**CITY OF SEATTLE
ANALYSIS AND DECISION OF THE DIRECTOR
OF THE DEPARTMENT OF PLANNING AND DEVELOPMENT**

Application Number: 2306026
Applicant: Dale Phinney for SHDP Partners
Address of Proposal: 11011 Meridian Ave. N.

Master Use Permit to establish use for future construction of a three-story, 69,000 sq. ft. medical office building with 3.5 levels of below grade parking for 277 vehicles and 54 surface parking spaces. The project includes demolition of a 10,000 sq. ft. restaurant building.

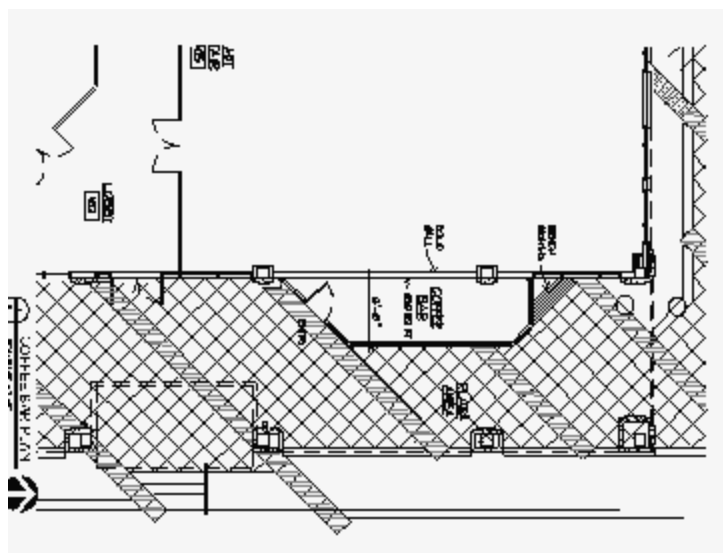
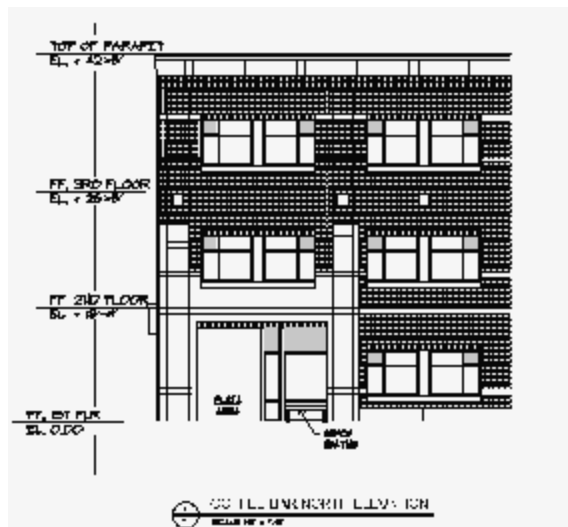
The long vacant Barnaby's restaurant building has no street level connection to the neighborhood whereas the proposed building has been designed through the City's design review process and in accordance with the Northgate Overlay District zoning provisions to have just such a street level connection and, in fact, positive contribution to the character of pedestrian experience. While the proposal is for an office building, its street presence and connection is well designed. It should provide a pleasant architectural addition to the commercial area. In order to insure that the new building and its uses do not detract significantly from the neighborhood serving commercial character of the area; the project will be conditioned to require the addition of a coffee and snack bar, enclosed and heated so as to allow all season use, in order to provide a service to users of the building and increase the human presence and activity in front of the building on the eastern side. This coffee and snack bar use is to remain open for the life of the project. This addition shall be designed so as to unobtrusively blend with the building architecture substantially as shown in the drawings below.

3. There shall be, for the life of the project, a coffee and snack bar, enclosed and heated so as to allow all season use in front of the building on the eastern side substantially as shown in the drawings show in the Conditional Use analysis above. This coffee and snack bar use will be kept open for the life of the project.
